Re: GSP Schiller Station NPDES Permit No. NH0001473
Permit Modification Request – Cooling Water Intake Structures (CWA § 316(b))

A PROPOSED BTA ALTERNATIVE TO WEDGEWIRE SCREENS AT SCHILLER STATION

March 30, 2021

Figure 1. Estimated entrainment abundance based on the proposed flow reductions (in green) from design intake flow (DIF) (in gray) at the existing cooling water intake structure (CWIS) at Schiller Station.

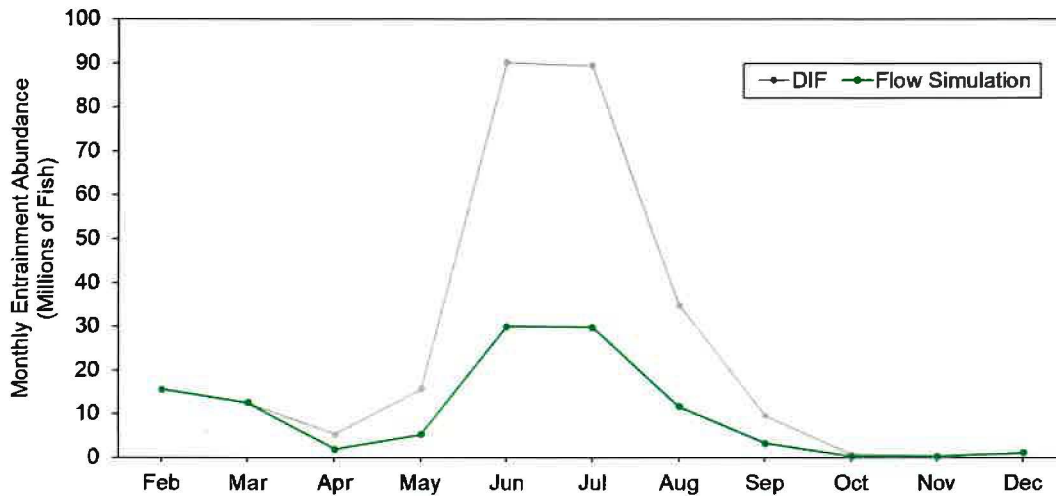
The goal of the model was to estimate annual entrainment reduction based on the selection of monthly AIF reductions, under EPA's assumption that entrainment is proportional to intake flow. With consideration of the seasonality of entrainment and the grid's power demands, GSP Schiller proposes a BTA alternative that reduces intake flow from 125.8 MGD to 41.8 MGD from April through October when the majority of entrainment takes place. This flow reduction scenario is estimated to reduce entrainment abundance by 59.2% compared to the estimated entrainment abundances at the permitted DIF (Figure 1, Table 1). The 59.2% reduction estimate for the proposed flow reduction alternative is substantially higher than the expected entrainment mortality reduction for 0.8-mm WWSs estimated for classifying WWS as BTA in the Fact Sheet (37.5%).

The performance of the BTA specified in the current version of the NPDES Permit compared to estimates from the flow reduction model show that it is possible to obtain effective entrainment mortality reductions greater with this proposed BTA alternative than the estimated effective entrainment mortality reductions from WWSs at Schiller Station. Moreover, the estimated performance of entrainment reduction using the proposed flow reduction alternative does not rely on assumptions related to the potential mortality of ichthyoplankton physically impacted by or impinged on a full-scale WWS installation. If approved by EPA as a BTA alternative and accepted as a modification to the NPDES Permit, flow reductions will be immediate, as the solution does
